TRES VAQUEROS WINDFARM PROJECT

Final Environmental Impact Report

Contra Costa County
Department of Conservation
and Development

October 2011

Tres Vaqueros Windfarm Repowering Project . 209132.02
Figure 2.2.1-1
 Environmentally Preferred Alternative Project Layout

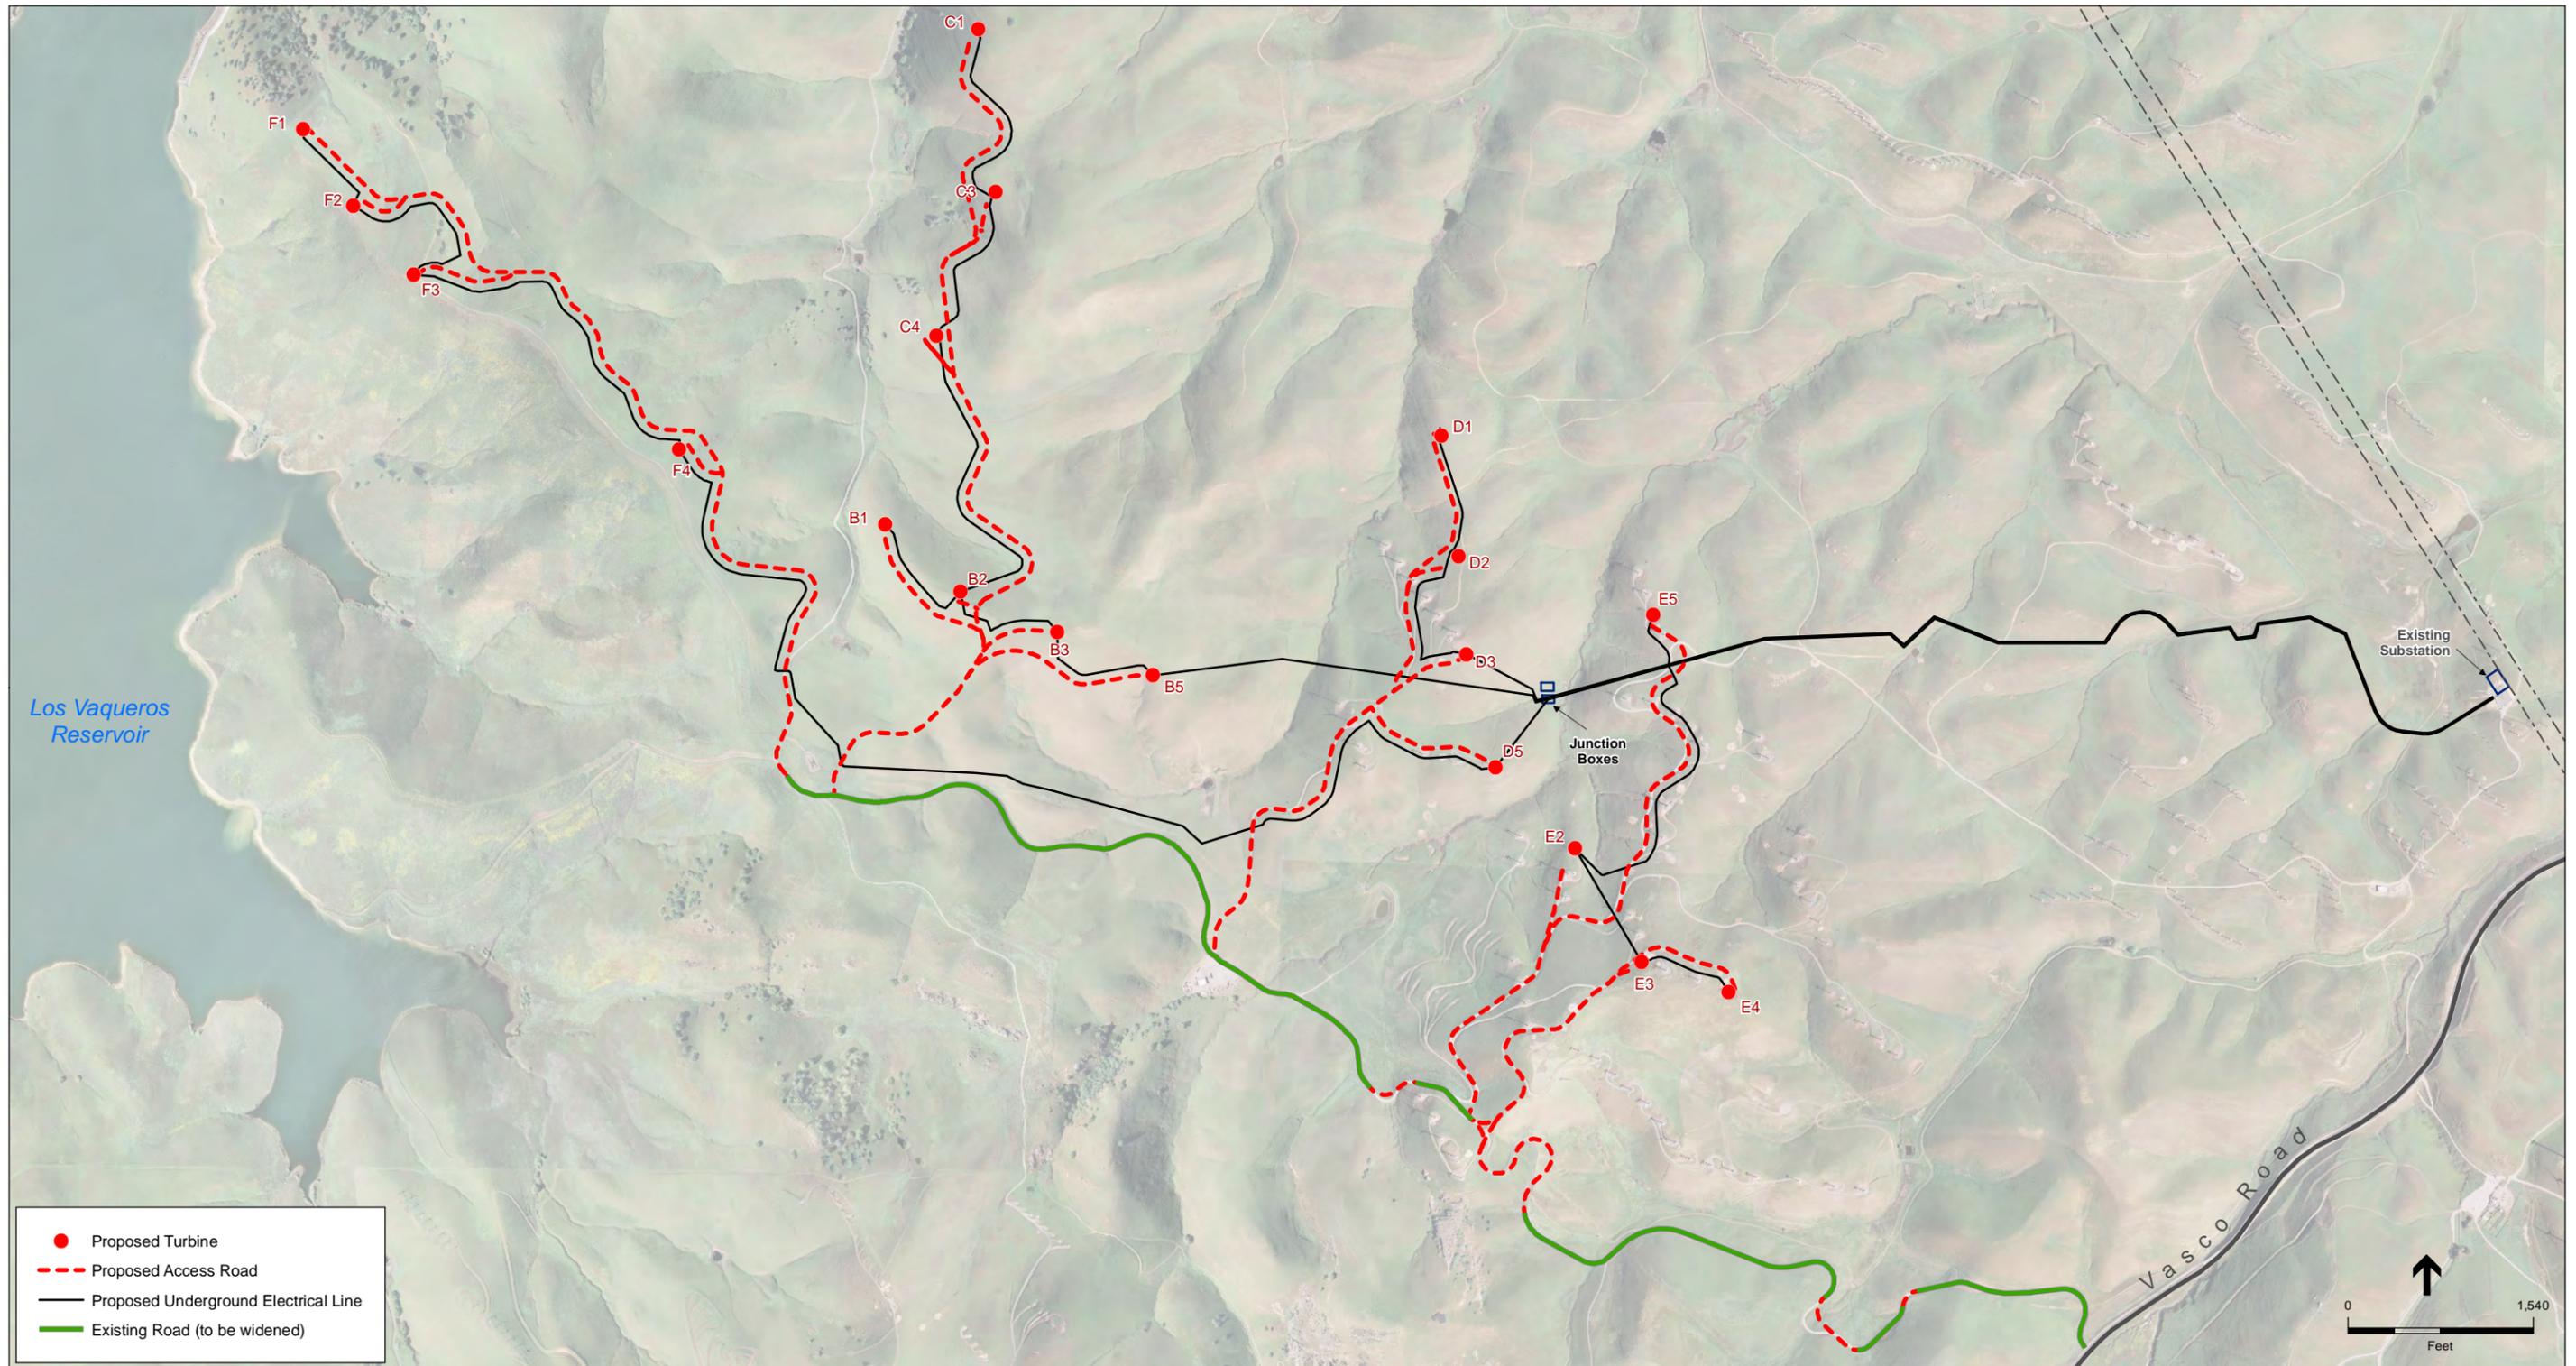
The essential differences between the Project and the Environmentally Preferred Alternative are:

1. The maximum number of installed turbines would be 19, two less than the maximum of 21 proposed by the Project;
2. The Environmentally Preferred Alternative involves construction of Siemens 2.3-101 (2.3-MW, 101-meter rotor diameter) turbines – other turbine models are no longer considered;

3. The site layout for the Environmentally Preferred Alternative eliminates the Project's A-string, reduces the B-string from 6 to 4 turbines, reduces the D-string from 5 to 4 turbines, and shifts the locations of several turbine sites along all strings except the F-string in response to a number of commenters' concerns and an additional round of micrositing (see Figure 2.2.2-1 compared to DEIR Figure 3-3);

4. Some roads proposed under the Project have been eliminated or realigned;
5. The total miles of new road would be reduced from 9.1 miles under the Project to 8.3 miles under the Environmentally Preferred Alternative, and the total miles of improved road would not change.

Tres Vaqueros Windfarm Repowering Project . 209132.02
Figure 2.2.1-3
 Estimated Noise Levels (dBA) Associated with the Environmentally Preferred Alternative

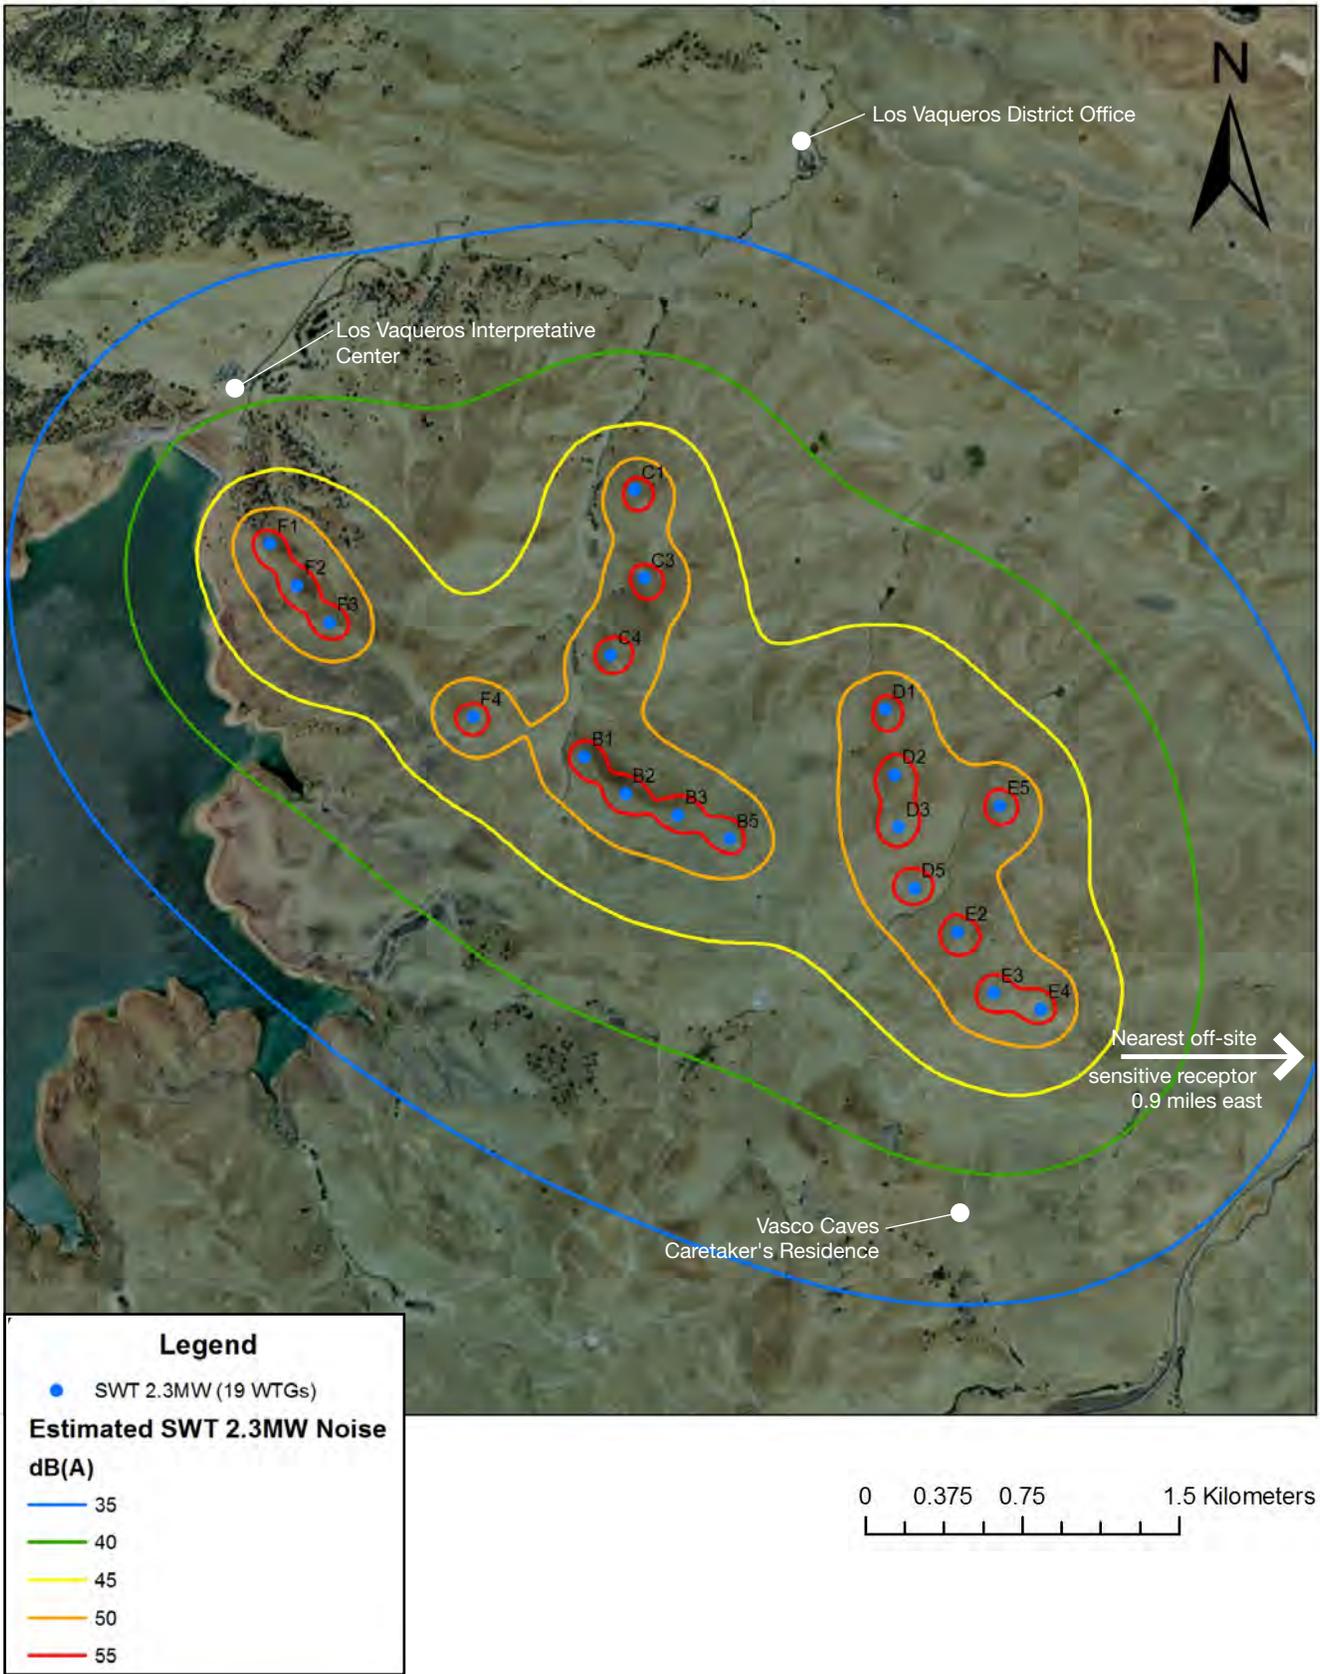
Figure 2.2.1-3 shows estimated noise levels (dBA) associated with the Environmentally Preferred Alternative. Figure 2.2.1-3 can be compared with DEIR Figure 4.13-2, which shows the same information for the Project. While the reduced number of turbines and the modifications to the turbine layout in the Environmentally Preferred Alternative necessarily result in changes to the noise contours, the similarities support the County's conclusion that the Environmentally Preferred Alternative would not cause a new or more significant noise-related impact in comparison to the noise impacts analyzed in the DEIR. Because of the similarities, the DEIR's discussion of noise impacts is also applicable to Figure 2.2.1-3.

Figure 1. Sample location of current site conditions, which include significant numbers of erosion gullies associated with culverts used for road drainage. Red arrows indicate culverts. Two photos showing the same culverts from 2 views.

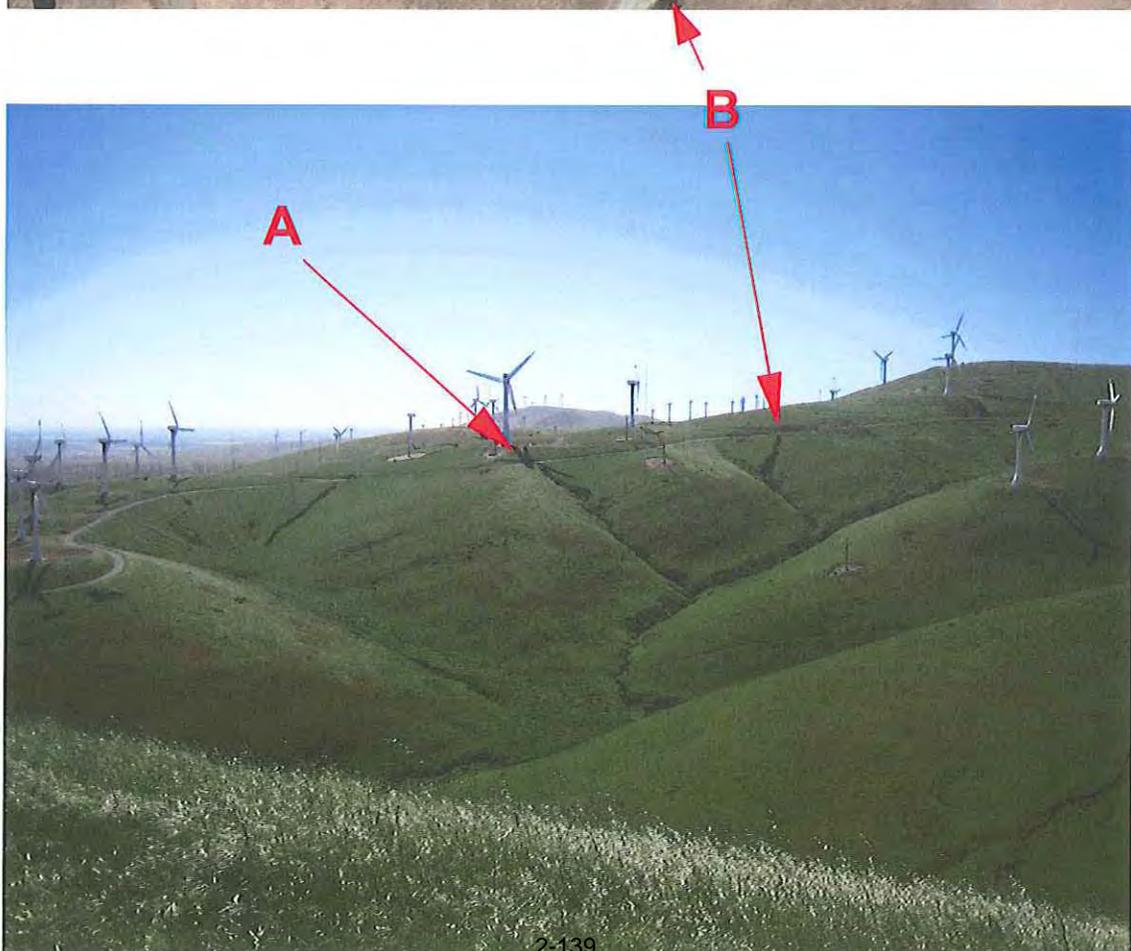
2. The DEIR does not adequately mandate mitigation measures that would ensure that erosion from culverts used to drain maintenance roads would be adequately maintained in a manner that would eliminate gully creation over the life of the Project. It does suggest BMPs would be implemented, however, those BMPs have not adequately addressed the same concern on the Initial Project where culverts and their eroded gullies are associated nearly 100% of the time (Figure 1).
